Re: Sound Study Package for Tatel Restaurant at 1 Lincoln Road a/k/a 1669 Collins Avenue (PB File No. PB0616-0037)

Reference: Sound Study Peer Review Response

Tatel Restaurant at the Ritz Carlton

Notes: Simulation for glazing system to increase Transmission Loss (TL) between restaurant and Ritz-Carlton lobby. 2 inch airspace between existing glass and 0.65" laminated glass.

File Name: Glazing System Design Drawing - 2 inch airspace.ixl

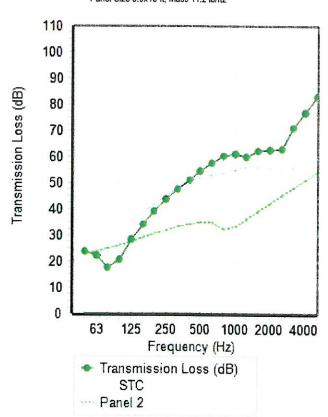
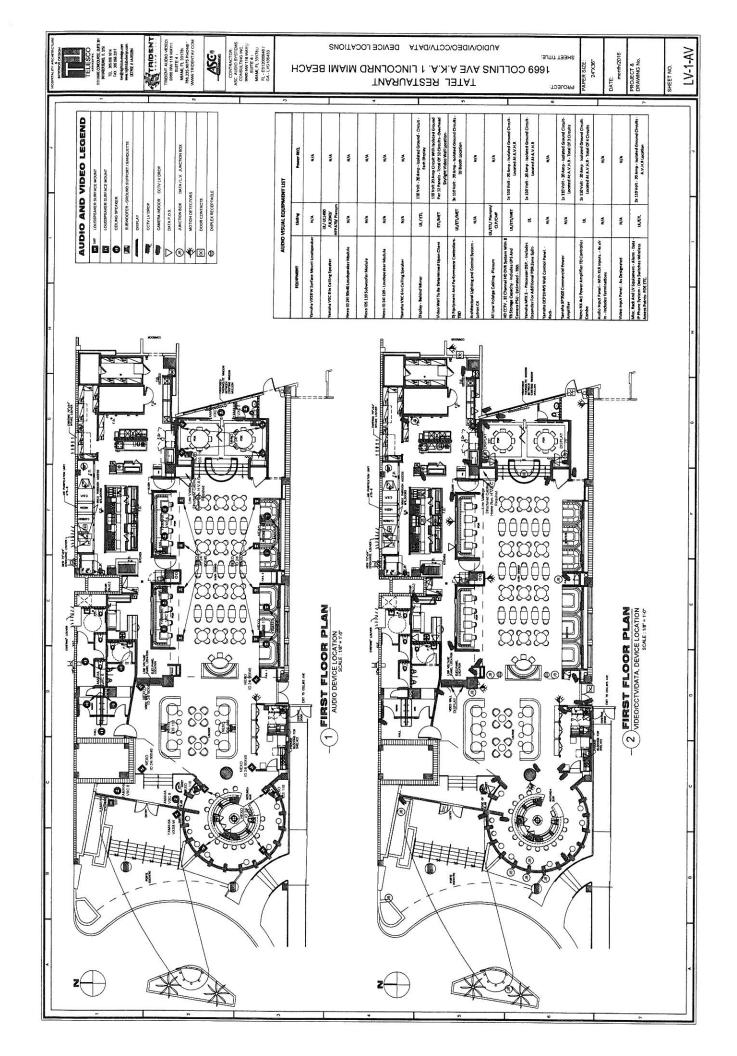
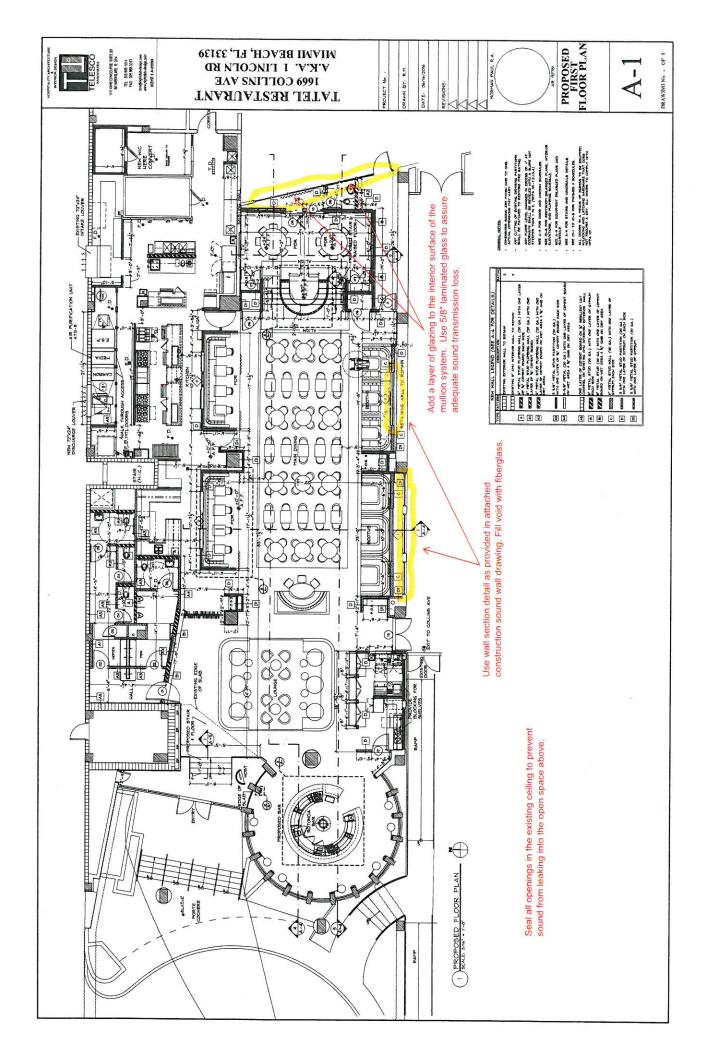
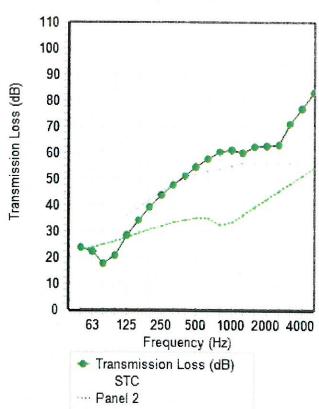
As an appendix to the sound study, there is a report to Telesco Construction Company dated June 14, 2016. This report presents two "temporary construction sound proofing" walls (one of which, while exhibiting an STC of 54, provides low sound transmission values of under 20 decibels at low frequencies under 100 hertz). These walls only appear to be mentioned on the plan on page 5. However, their purpose is not revealed and why they are temporary is not discussed. Additionally, while the plan on page 5 does show such a "temporary" wall at the south corridor, the double door between the venue and corridor, which would likely be the weak link for sound transmission, is not addressed. The report discusses glazing recommendations, including a recommendation to add a laminated pane to the east wall to achieve an STC of approximately 53 which, according to the report, will "eliminate any potential impact on the Ritz-Carlton lobby." However, there is no evidence, in the form of anticipated venue sound levels, to back up this claim. While an STC 53 partition is not insignificant, where source sound levels are high and background sound levels in a receiving room are low, there is no guarantee that such a wall will be sufficient.

We have been working with the construction team to develop permanent solutions for the east glazing wall, the double door along the corridor and the corridor wall. These are provided below.

> STC 52 OITC 34
